## **Suffolk County Council (20041323)**

Comments on any other submissions received  
at Deadline 7

## **Bramford to Twinstead (EN020002)**

Deadline 8

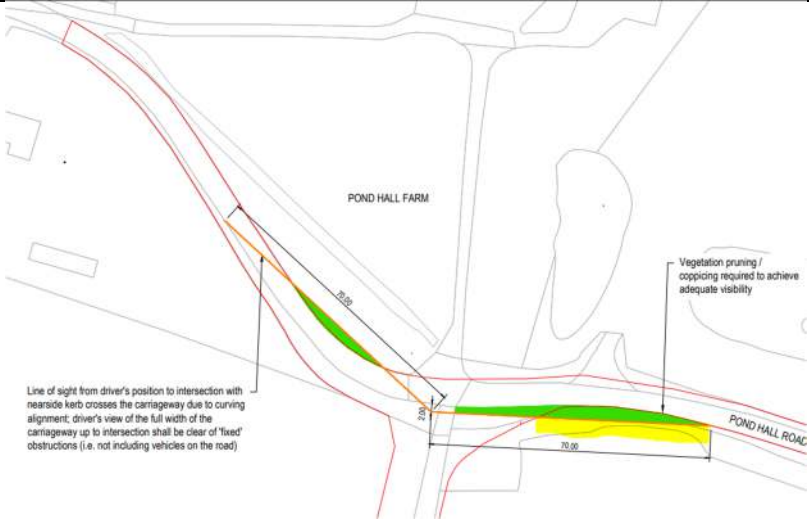
<i>acceptable within the limits of any land currently controlled by the Applicant or land forming part of the maintainable highway.'</i>
7c	Purpose of this Technical Note	1.3.5	<p>There are a large number of tools at the Applicant’s disposal to deliver appropriate accesses and different solutions would be sought at different accesses; these include:</p> <ul style="list-style-type: none"> <li>• Improving the physical design of the access and/ or creating a new access with improved bellmouths and visibility;</li> <li>• Speed restrictions to temporarily reduce the speed of vehicles along the road;</li> <li>• Traffic management including road closures and temporary traffic signals; Temporary traffic regulation orders, a number of which have been listed in the draft DCO, and additional orders which could be sought if required;</li> <li>• Management of construction vehicles (type, number, arrival</li> </ul>	<ul style="list-style-type: none"> <li>• Improved bellmouths – see above.</li> <li>• Speed limits and traffic management are only proposed to be temporary in the construction phase and would not be available for permanent accesses used in the operational phase. Whilst the volume of use may be low and / or intermittent such junctions must be designed to appropriate standards. Traffic management which involves stopping opposing flows of traffic is only practical on roads that have space for the vehicles to pass each other (for HGVs nominally a minimum 5.5m at low speed).</li> <li>• Removal of vegetation on private land not within the order limits would need the landowners permission. At this stage this cannot be taken as granted.</li> <li>• SCC would agree that there is scope to rationalise the number of accesses (see below).</li> </ul>

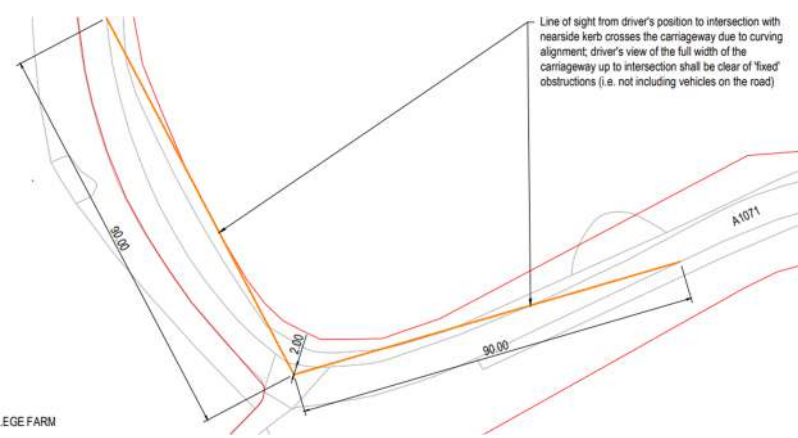
<p>times);</p> <ul style="list-style-type: none"> <li>• Additional vegetation removal on highways or private land;</li> <li>• Banksman operation, whereby a works employee assists the driver of a works vehicle entering or leaving the site; and</li> <li>• Use of alternative accesses and/or of a temporary access route along the order limits where the above measures cannot result in an suitable access at the point depicted in the plans.</li> </ul>	
7d	AB-AP5: Church Hill, north of Burstall			<p>SCC (LHA) visited this location during a site visit. Its observations noted that to obtain 90m visibility to the south it estimated that a few immature saplings in form of the hedge will require removal and the majority of the hedge cut back close to the stems and potentially a number of trees. This hedge is not considered to be within the highway limits, nor the order limits. Construction of the bellmouth will also require removal of immature trees to the south and temporary culverting of a ditch to the north.</p> <p>SCC (Landscape) notes that the alternative AB-AP4 at first appears preferable in landscape terms; however, it would</p>

require removal of a considerable stretch of important hedgerow (H-AB-077). The loss of vegetation at AB-AP5 could include the loss of trees (the hedgerow at AB-AP5 is not clearly identified).
7e	AB-AP4			SCC (LHA) notes that to obtain a minimum visibility splay of 90m a significant length of hedge either side will require coppicing. An area to the north is likely to fall outside the limits of the highway or order limits.
7f	AB-AP3			SCC (LHA) notes that to obtain a minimum visibility splay of 90m a significant length of hedge either side will require coppicing.
7g	AB-DAP6: Duke Street, Hintlesham			<p>SCC (LHA) notes that to obtain the necessary visibility it is likely that the private hedge to the north of the access will require trimming. The order limits seem to exclude the driveway to the north and therefore it would appear difficult to deliver a bellmouth as shown in <b>[APP-030]</b> particularly as the order limits are restricted immediately adjacent to the highway as shown in drawing B2441B04-JAC-TE-B2T-APVS-ABDAP6-001 in <b>[REP7-027]</b>.</p> <p>A swept path analysis would be necessary to confirm that vehicles can enter and exit within the order limits.</p>
